From: Craig Hoffman
To: Kourtney Vaccaro
Date: 8/11/2010 1:31 PM
Subject: Abengoa PMPD unofficial early comments.
Attachments: June 28 agreed upon conditions.doc; AMS_Biology Fig 1 (Mar 2010).pdf

DOCKET
09-AFC-5

I will have other edits, but I have 4 easy ones for you.

BIOLOGICAL RESOURCES - FIGURE 1

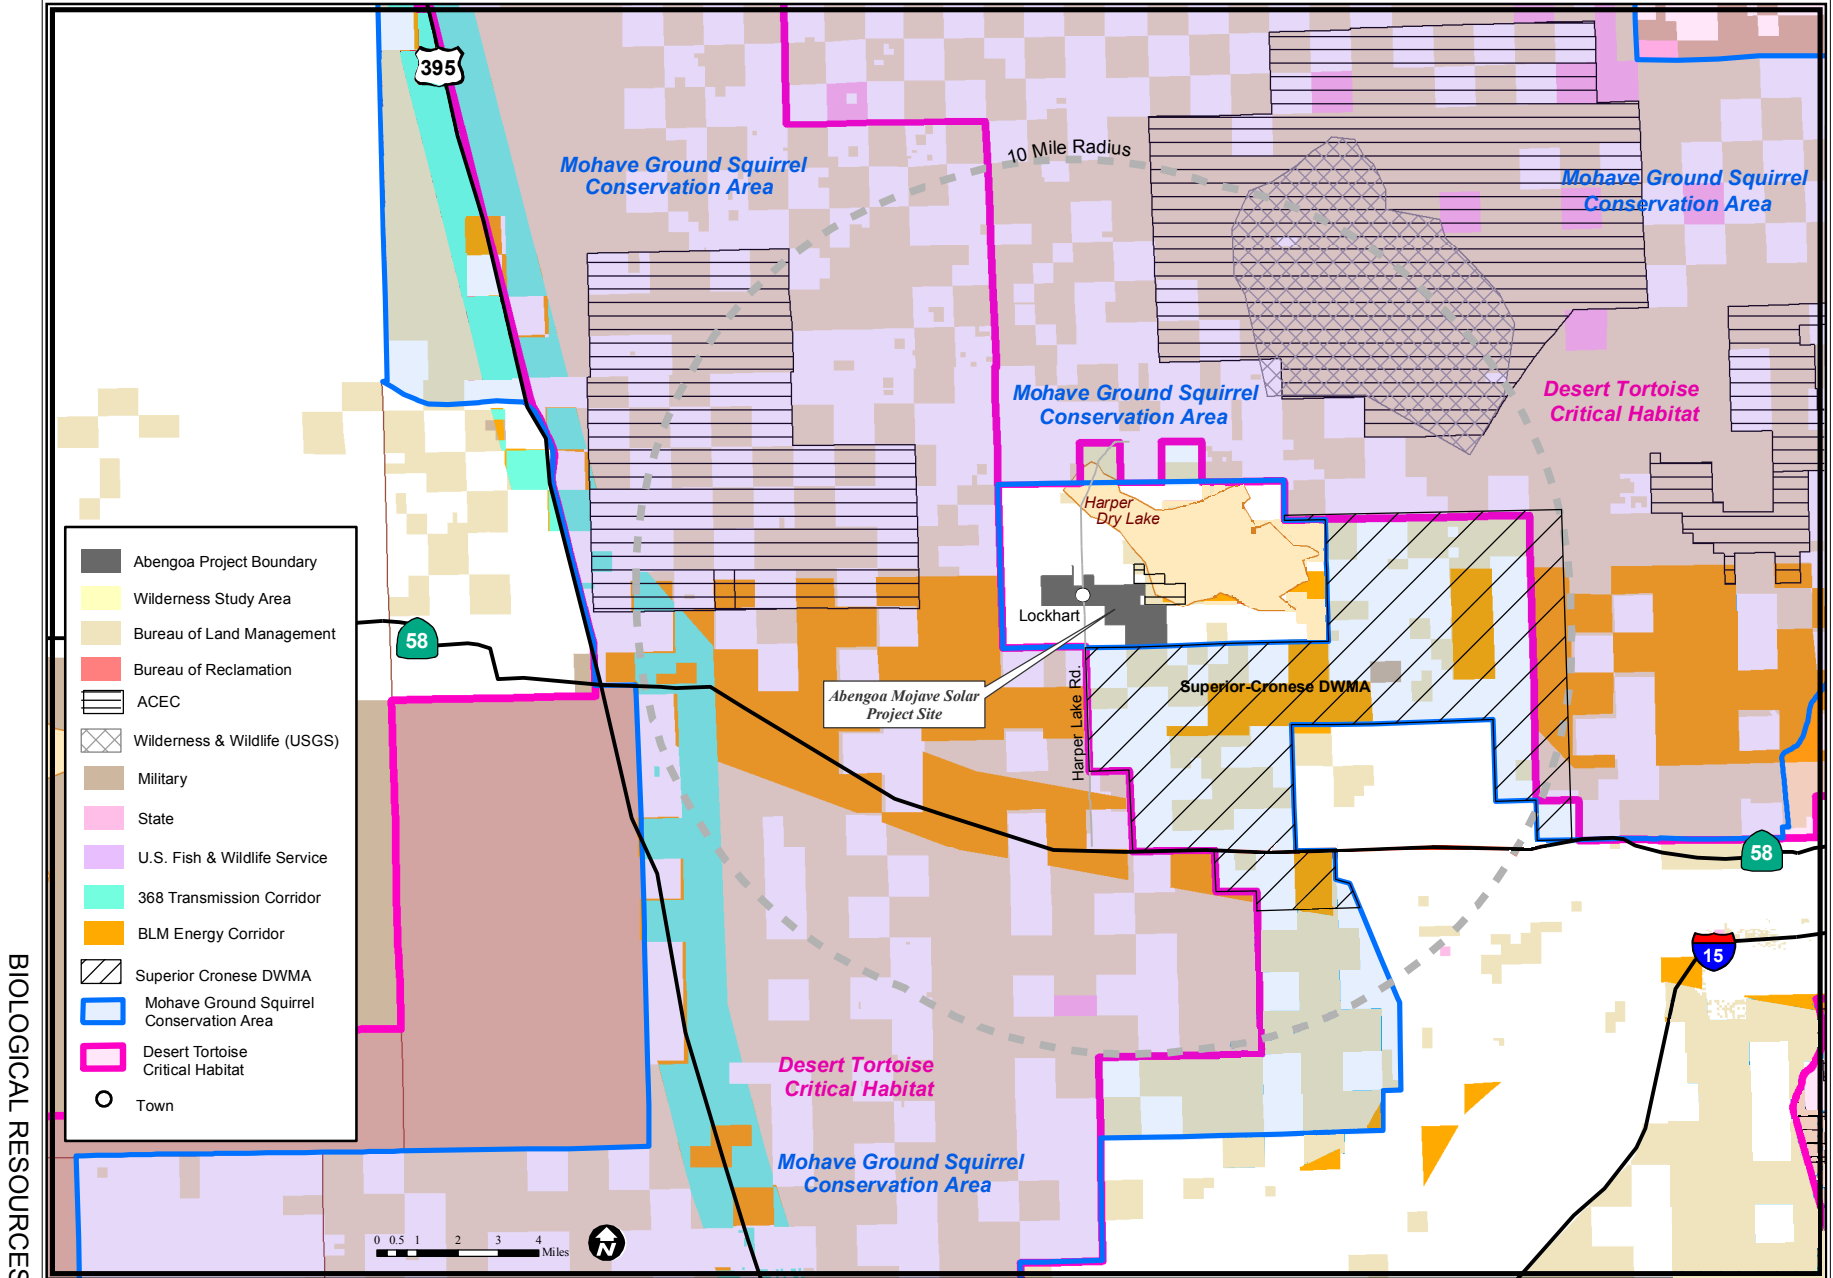
Biology. Attached is the correct Bio figure 1
